July 8, 2008

MEMORANDUM

SUBJECT: Bayview Water and Sewer District Wastewater Reuse Permit Application Review
– LA-000105-03 (Municipal Wastewater)

Figure 1 Hydraulic loading trend for Bayview Water and Sewer District

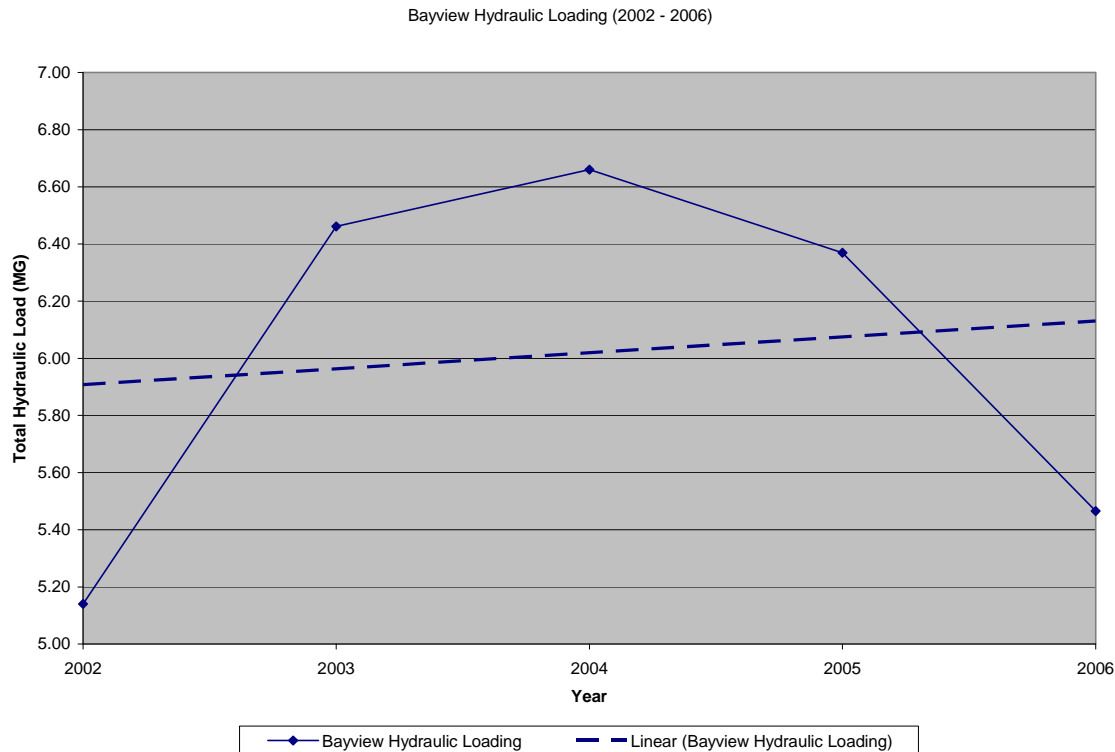
Growing season hydraulic loading should be substantially equal to the irrigation water requirement (IWR) for a forested site. As discussed in Section 4.4.1, the facility has not yet approached the maximum hydraulic limit of 14.5 MG developed for the current permit (see attached memo in Appendix 7.1). Figure 1 shows the trend in hydraulic loading for the current permit cycle (2002 through 2006). Over the first four years of operation, the maximum hydraulic loading occurred in 2004 and has decreased each year since then. The dashed line is the linear trend of the data and shows that the facility will not even approach the current permit limit of 14.5 MG until well beyond the next permit cycle, if the trend continues.

Due to nutrient loading concerns which will be discussed in Section 4.4.2.2, it is proposed that a hydraulic loading limit of 8.90 MG be imposed for the next permit cycle as shown in Table 1. Since there is little water use data for trees, the forest at the application site was approximated with values taken from the ET_{Idaho} website for 25% Orchard without Groundcover and 75% Range Grasses with a sprinkler efficiency of 85%. Please see Appendix 7.2 for a fuller description of the process used to derive the irrigation rates.

Figure 2 Wastewater Nitrate-N Loading Trends for Bayview Water and Sewer District

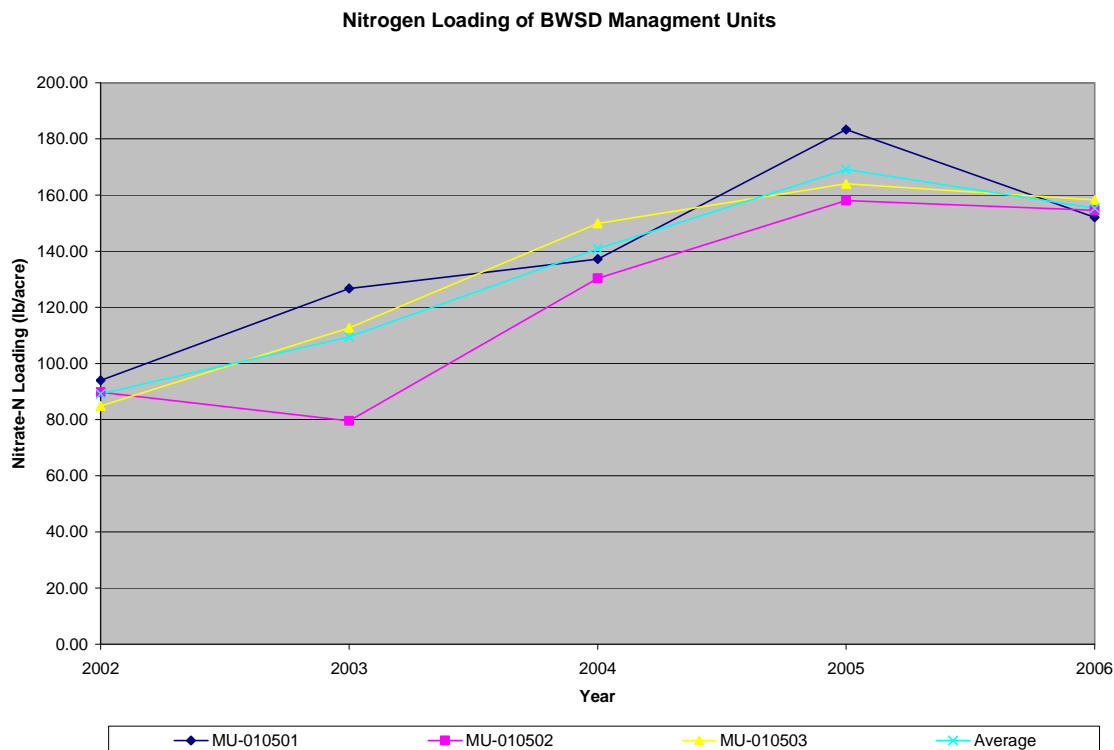
According to the facility's annual reports (see Figure 2), the total nitrogen applied to the entire site has ranged from 89.2 lbs/acre in 2002 (BWSD, 2003) to 169.1 lbs/acre in 2005 (BWSD, 2006) and these loading practices do not appear to have been detrimental to the site. The current limit, as stated in the permit, is "125% of typical crop uptake, or UI Fertility Guide." The "typical crop uptake" for this site has been previously estimated to be 80 – 220 lbs/acre as stated in the application materials (BWSD, 2007b) and the memorandum accompanying the current permit (see Section 7.1 of the Appendix). No changes to the nitrogen loading limits were requested by the facility; however staff intends for this permit be consistent with other permits for forested sites by developing numerical constituent loading rates that are representative of the vegetation on the site. BWSD's application site consists of primarily Douglas fir with significant understory due to past logging activities in the area. Data (Henry et al, 1999) for Douglas fir estimates nitrogen uptake for a juvenile plantation (aged 3 – 25 years) at 110 lbs/acre for complete canopy and the understory at 100 lbs/acre, depending upon coverage. The canopy was estimated to be 75% of full canopy with 100% understory coverage, which gives a numerical value for the nitrogen uptake of 183 lbs/acre, as shown below. At 125% of crop uptake, the nitrogen loading limit for the next permit cycle is 228 lbs/acre.

The facility's nitrogen application for 2006 appears to be lower than previous years, which makes forecasting loading trends difficult. Regardless of whether 2006 is merely an anomaly or a true representation of an improvement in the facility's nitrogen loading rates, for the next permit cycle BWSD is encouraged to work with the Regional Office to develop additional means to ensure that their loading rates remain below 228 lbs/acre.
